**STAFF REPORT**  
**COMMUNITY DEVELOPMENT DEPARTMENT**

SUBJECT: H-2021-0061  
 Elsinore Child Care Facility

LOCATION: 4818 & 4858 N. Elsinore Avenue,  
 generally located at the northwest corner  
 of Meridian Road and McMillan Road.

Conditional Use Permit request to construct a new 13,535 square foot, single-story daycare facility on approximately 1.3 acres of land on Lots 12 & 13 of the Paramount Square Subdivision in the C-G zoning district, by 814 Development, LLC.

**A. Site Plan (no date) NOT APPROVED**

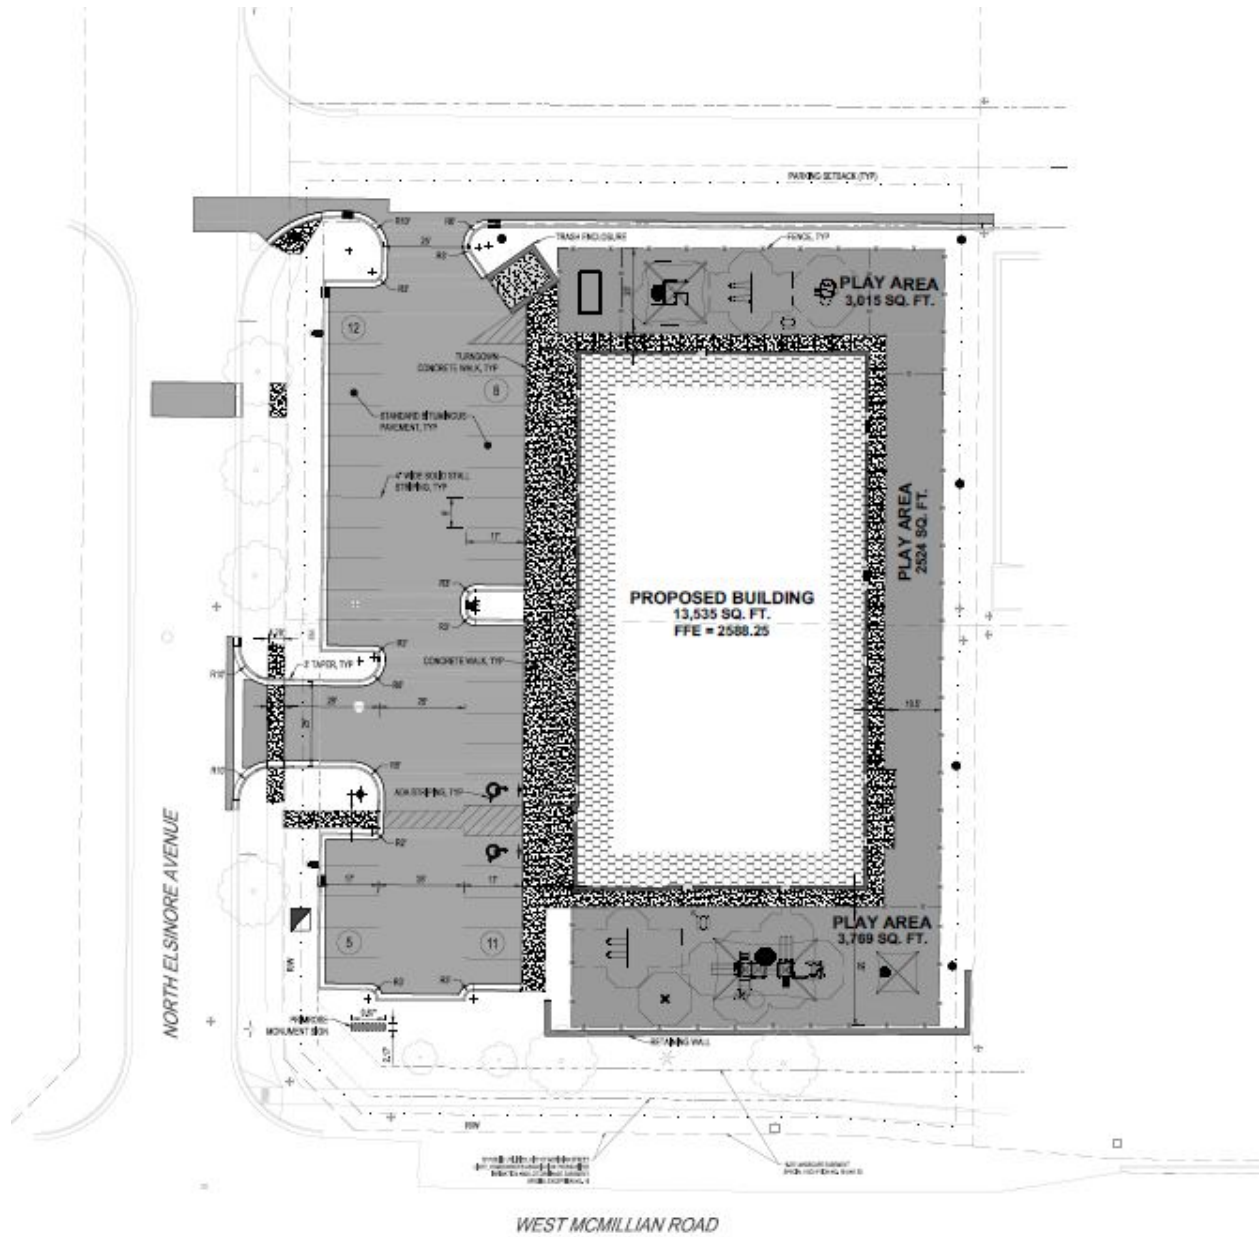
*The submitted site plan shows a two-way, 25-foot wide drive aisle along the west side of the building with parking on both sides to equal 36 total parking spaces. The building is shown as approximately 13,500 square feet requiring a minimum of 27 parking spaces per code requirements for nonresidential uses (1 space/500 square feet). Therefore, the Applicant is proposing parking in excess of code requirements. However, the site plan does not show any dedicated pick-up/drop-off location other than the parking spaces. The Applicant is proposing two points of ingress/egress for the subject site; one access to Elsinore Avenue to the west and one access to the north to the existing shared drive aisle that runs east-west through the commercial development. The inclusion of two access points for the parking area provides more than one avenue for parents to access the site.*

*In addition, ACHD is requiring a dedicated westbound right-turn lane and a dedicated eastbound left-turn lane to Elsinore Avenue from McMillan Road. With these dedicated turn lanes and multiple ways to access the subject site, some of Staff's concerns regarding access are mitigated. However, Staff does have concerns the proposed parking drive aisle could be overrun at peak pick-up/drop-off hours in the morning and afternoon with the current site design. During discussions with the Applicant, it has been noted the daycare operator prefers parents to park to discharge and pick-up their children instead of simply a quick stop-and-go drop-off. To help mitigate this concern, Staff recommends a reduction in building size to allow for additional parking along the north end of the site, similar to what exists within this commercial development to the east. See below:*

*If a similar sized parking area is included on this site, approximately an additional 10 parking spaces should be able to be added to the site to total 46 with this recommendation. Staff does not anticipate the play area along the north boundary being reduced with the inclusion of additional parking because the building itself should be reduced in size, nothing else. Staff has recommended a condition of approval commensurate with this option.*

UDC requires that new commercial buildings provide 5-foot wide sidewalks from all public entrances to the arterial sidewalks. The submitted plans show one such connection via striping across the drive aisle and a small segment of sidewalk to the sidewalk along Elsinore; no other sidewalk connections to the existing sidewalk network are proposed. Per *UDC 11-3A-19B.4b*, pedestrian facilities that traverse vehicle use areas (including drive aisles and parking lots) shall be constructed in a material different from the driving surface to clearly separate the pedestrian facility from the driving surface—painted striping does not satisfy this requirement. Therefore, Staff is recommending a condition of approval to revise the site plan to show any pedestrian facility that crosses a driving surface be constructed with stamped or colored concrete, brick pavers, or similar to meet this code requirement.

Code requires an additional connection to the sidewalk along McMillan Road, an arterial street, and the most logical and feasible place for this to occur is by continuing the sidewalk south along the front of the building and connect to the McMillan sidewalk within the existing landscape buffer. In addition, with Staff's recommended changes to the north end of the site to add parking

or create a pick-up/drop-off area, additional 5-foot sidewalk should be added adjacent to the new vehicle use area to connect to the sidewalk at the front of the building for safe access to the building.

6. The site plan and landscape plan shall be revised as follows prior to the Commission Hearing:
  - a. Revise the site plan to show a reduced building size to accommodate additional parking at the north boundary of the site adjacent to the shared drive aisle similar to what exists to the east.

- b. In accord with UDC 11-3A-19B.4, show any pedestrian facility that crosses a driving surface be constructed with stamped or colored concrete, brick pavers, or similar;

- c. Add a sidewalk connection from the site to the existing sidewalk along W. McMillan Road in accord with UDC 11-3A-19B.4;
  - d. Revise the type of fencing proposed around the perimeter of all play areas to be non-scalable per the specific use standards listed in UDC 11-4-3-9 (*i.e. wrought iron fencing or vertical steel tube fencing*);

- f. Include the turn lanes required by ACHD from W. McMillan Road to N. Elsinore Avenue—an eastbound center left turn lane and a westbound right turn lane; prior to Certificate of Occupancy for the building, the Applicant shall provide proof to the Planning Division that these turn lanes have been constructed per ACHD requirements.

B. Landscape Plan (no date) **NOT APPROVED**

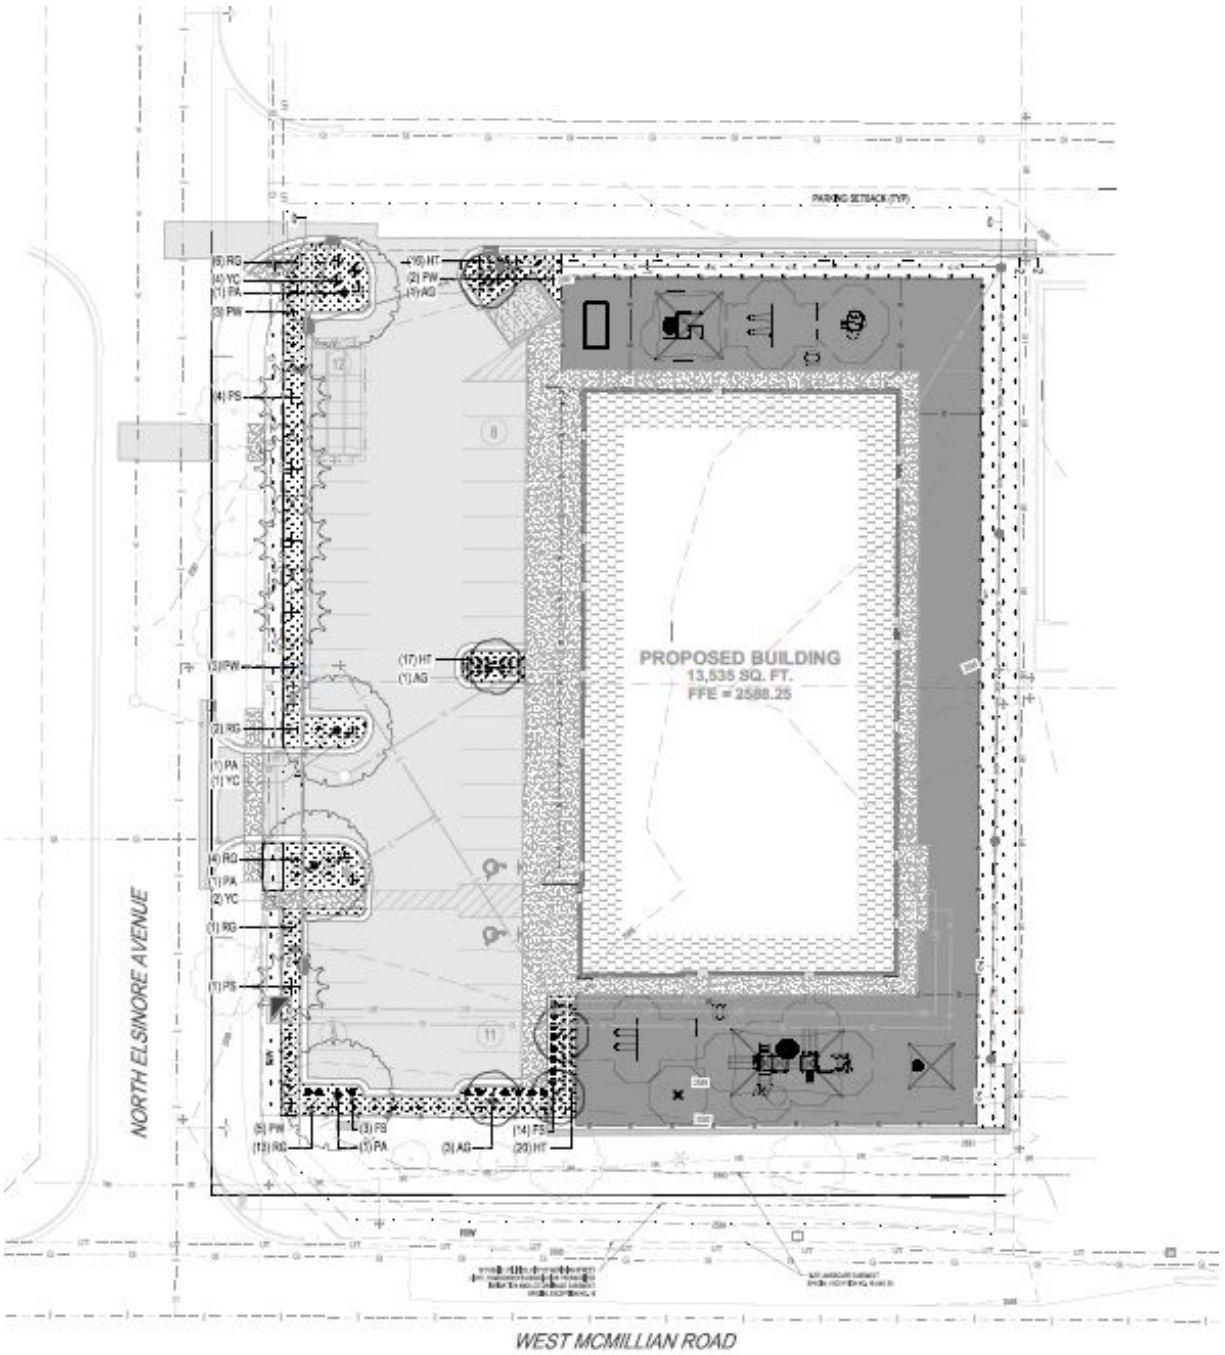
1. All outdoor play areas shall be completely enclosed by minimum six foot (6') non-scalable fences to secure against exit/entry by small children and to screen abutting properties. *The submitted landscape plans show a 6' vinyl coated chainlink fence along the perimeter of the play areas which surround the building on the north, east, and south sides. Chainlink fencing does not qualify as non-scalable fencing so the Applicant is required to revise the fencing material. Staff is recommending a condition of approval to provide fencing consistent with code requirements (i.e. wrought iron fencing or vertical steel tube fencing).*  
*The outdoor play area may be reduced in size as a secondary consequence of requiring more parking or a discharge/pick-up area along the north boundary of the site. However, Staff is also recommending the building size be reduced which should not inherently require the outdoor play areas also be reduced.*

The project requires a 25-foot landscape buffer to McMillan Road, an arterial street, and a 10-foot buffer to Elsinore Avenue, a local street, per C-G dimensional standards in UDC Table 11-2B-3. Both of these required buffers are already existing and contain the detached sidewalk. However, the submitted landscape plans do not show the existing buffers and landscaping and this should be corrected with future plan revisions to ensure the adequate buffer width is maintained. Staff's recommendations to revise the site plan to accommodate more parking should not alter any landscaping requirements. In addition, the requirement to construct a right turn lane onto Elsinore Avenue should also not affect the existing buffer because there is adequate space for this. Should this not be true, the Applicant is required to maintain the minimum 25-foot buffer width. All other landscaping proposed is for the parking lot landscaping and appears to meet UDC standards.

- e. Show the existing and required street buffers along N. Elsinore and W. McMillan. The existing landscaping shall be protected during construction in accord with UDC 11-3B-10;
